35-1195
Comanche Peak Steam Electric Station
Special Engineering Instruction

Installation of Containment Anchor Bolts,
Nuts and Plates

COMANCHE PEAK STEAM ELECTRIC STATION
DESIGN CHANGE/DESIGN DEVIATION AUTHORIZATION

COMANCHE PEAK STEAM ELECTRIC STATION
1980-82 2300 MW INSTALLATION
ENGINEERING REVIEW AND METALLURGICAL
ASPECTS OF TACK WELDING OF BOLTS
REF: NCR #704 AND #722

CASE 1

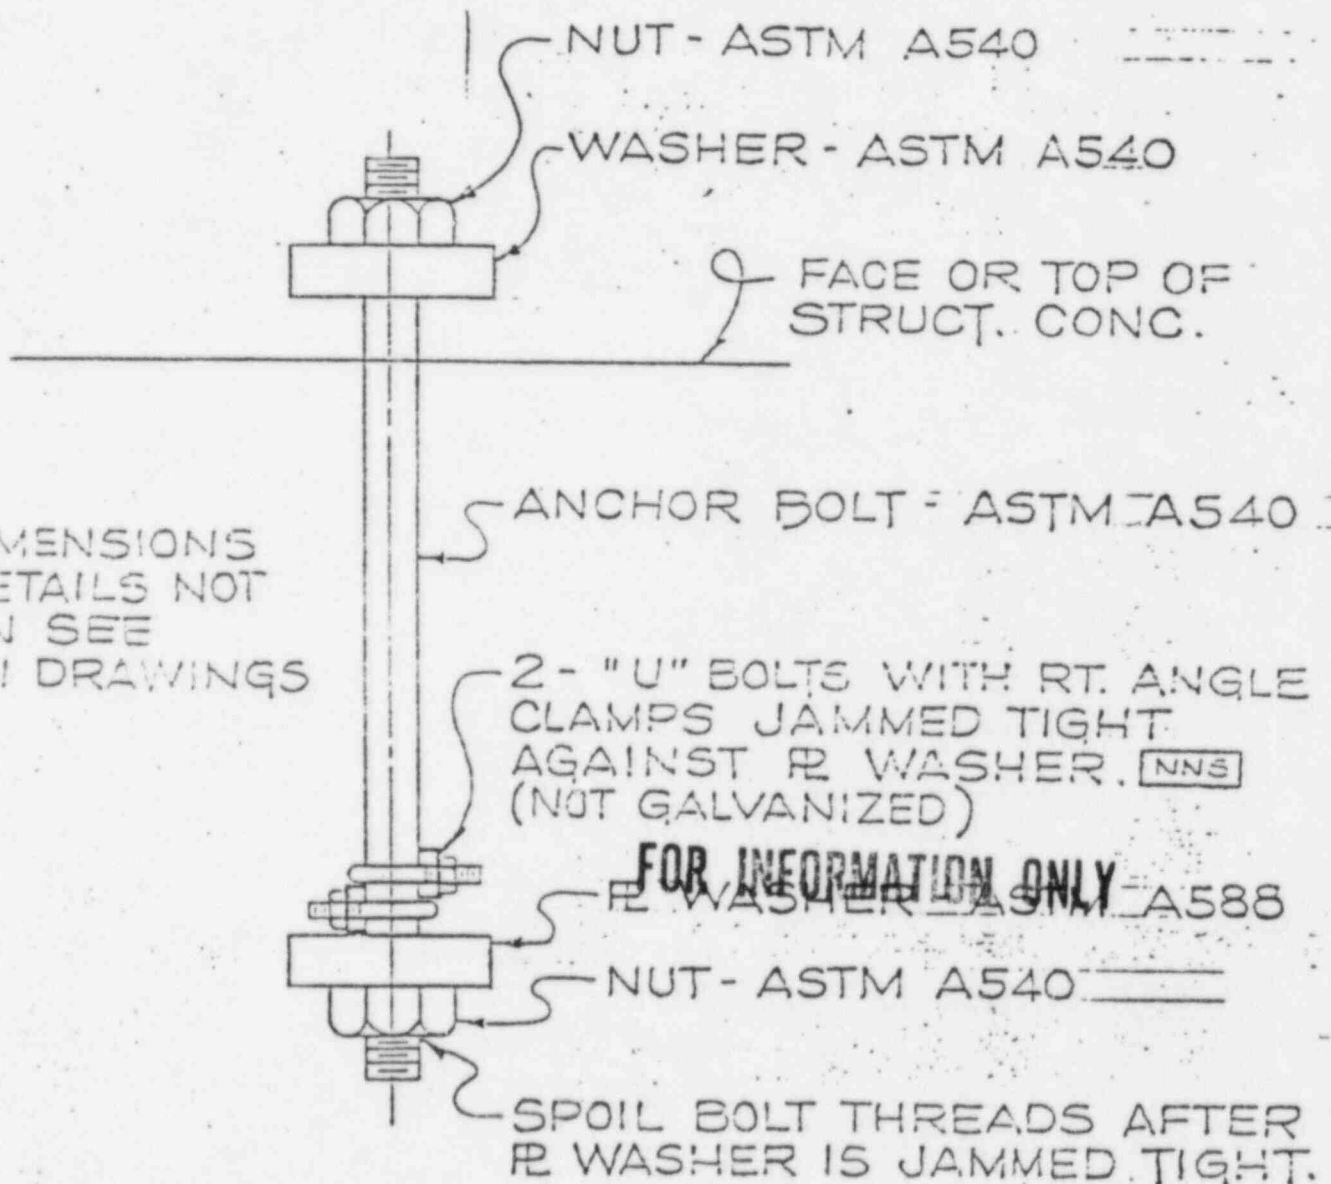
- 1) THIS DETAIL MUST BE USED FOR ALL ASTM A540 ANCHOR BOLTS THAT WILL SUPPORT WESTINGHOUSE SUPPLIED EQUIPMENT.

GHF-1789

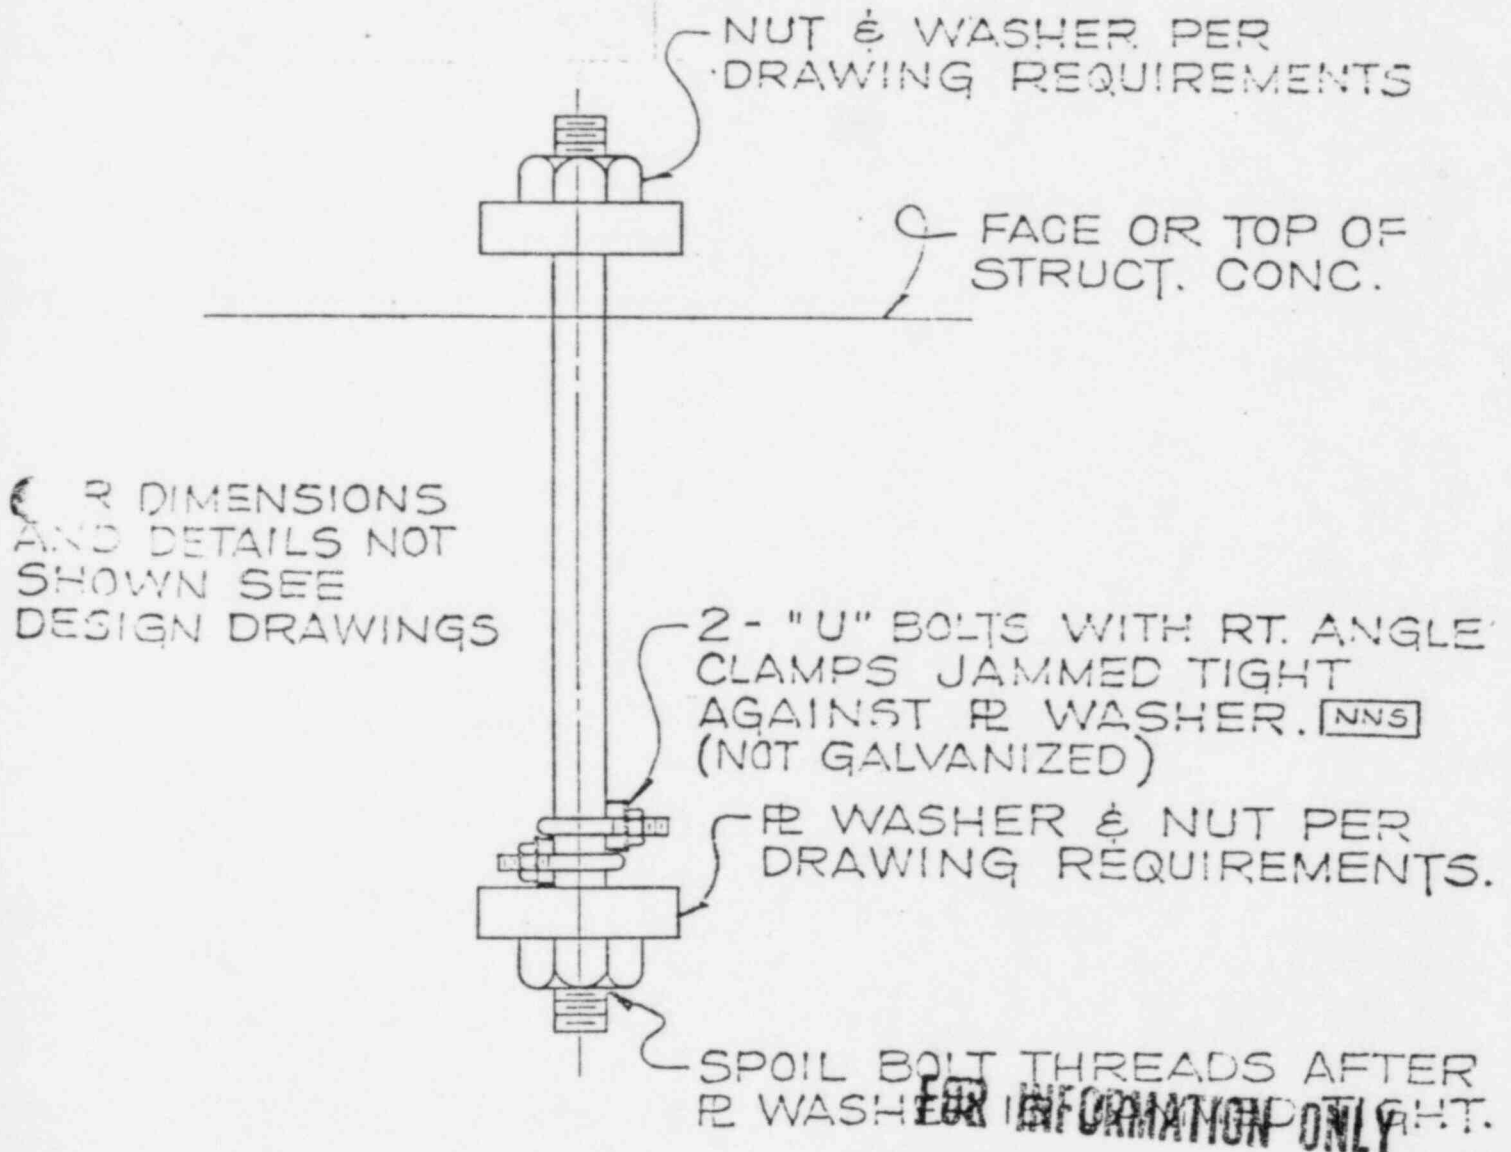
Regarding the referenced letter which imposed a hold on welding to anchor bolts, we are transmitting the attached sketch which shows an alternate mechanical connection.

This detail was reviewed by the Design Engineer on Tuesday, July 12, 1977. At that time, he confirmed that this configuration would satisfy the basic concern that the plate washer be held securely in place prior to and during concrete placement activities.

Based on the Design Engineer's comments, this change will have no detrimental effect on plant safety. Therefore, in accordance with the G&H policy as of July 13, 1977, this change is authorized by the undersigned in advance of formal changes to the design documents.

Construction may proceed subject to your approval.
